Office Action Summary

10/693,981

TAMURA, MASASHIGE

Claims 1-5 are rejected under 35 U.S.C. 102(b) as being anticipated by Notani et al. (JP 2000066500).

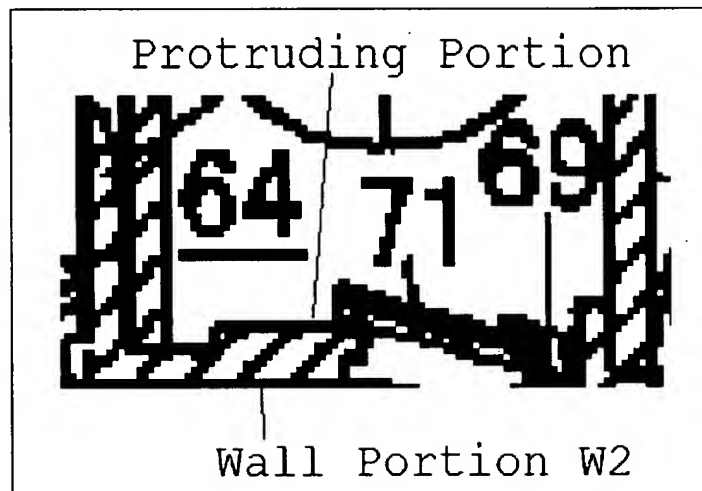
Notani et al. disclose an image forming apparatus in figure 27 including: a developing device (Dm) containing developer including toner and carrier, the developing device (Dm) having a first chamber (62) for developing an electrostatic image formed on an image bearing member (16), and a second chamber (64) constituting a developer circulating route between the second chamber and the first chamber, as shown by figure 7.

A carrying member (R2) is rotatably provided in the second chamber (64) for carrying the developer, and a rotary member (H) holds the developing device (Dm) and is rotatable in a route including a developing position. Supplying means (R1) is for supplying the developer to the developing device, which is in the developing position.

Shutter (71) is a valve mechanism for opening and closing the opening (67a) by operation of gravity of the valve mechanism with the rotation of the rotary member.

Developer exhaust port (67a), or alternatively end connection (74), is an opening provided in the second chamber (64) for outwardly discharging therethrough any excess developer resulting from the supply of the develop.

Upper wall (W2) is a wall portion provided in the second chamber on a side on which the opening and closing member (71) is opened. A portion of developing device (Dm) from figure 27 is shown below, which shows that wall portion (W2) has a protruding portion protruding toward an inside of the second chamber (64).

Regarding claim 2, the wall portion (W2) is provided between the opening (74) and the carrying member (R2) so as to narrow a developer containing space in the second chamber (64).

Regarding claim 3, the opening (67a) is located above the wall portion (W2) when the excess developer can be discharged through the opening, for example in the case of Dm in figure 27.

Regarding claim 4, the second chamber (64) has a substantially U-shaped cross section, and the wall portion is provided so as to protrude from a straight portion of the U-shape toward the carrying member side.

Applicant submits that Notani et al. do not teach a protruding portion of a wall portion that protrudes toward an inside of the second chamber. However, as indicated in the figure above the wall portion (W2) of Notani et al. is clearly sectioned, having one portion protruding toward an inside of the second chamber.
